Arkansas Department of Transportation
Bridge Inspection Program Assessment
Final Report

BRIDGE INSPECTION PROGRAM ASSESSMENT
ARKANSAS DEPARTMENT OF TRANSPORTATION
FINAL REPORT

BY
FEDERAL HIGHWAY ADMINISTRATION

Figure 5. InspectX 2.4.2. Screen shot of Files tab showing list of stored files.

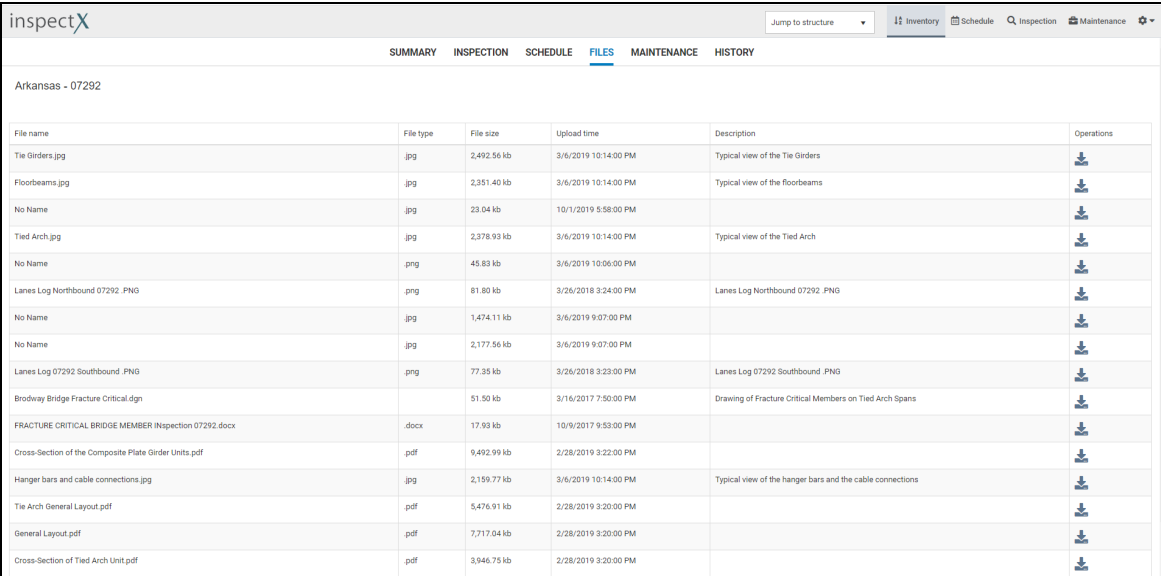
The Team observed many files under the InspectX Files tab did not have a description and several had “No Name” as the filename for several bridge files reviewed. Additionally, there was an upload time shown for the files, but it was not clear if the date was the appropriate date for information in the file. A standard file naming convention should be developed and implemented that includes a clearer description of the file content and more representative date (e.g., 07292 Channel Cross Sections 20210121.xlsx). See Figure 5.

The Team believes now that ARDOT is using InspectX as their bridge record/file system, this type of correspondence is significant and should be stored and maintained in InspectX, likely under the Files tab for the bridge asset. See Figure 5.
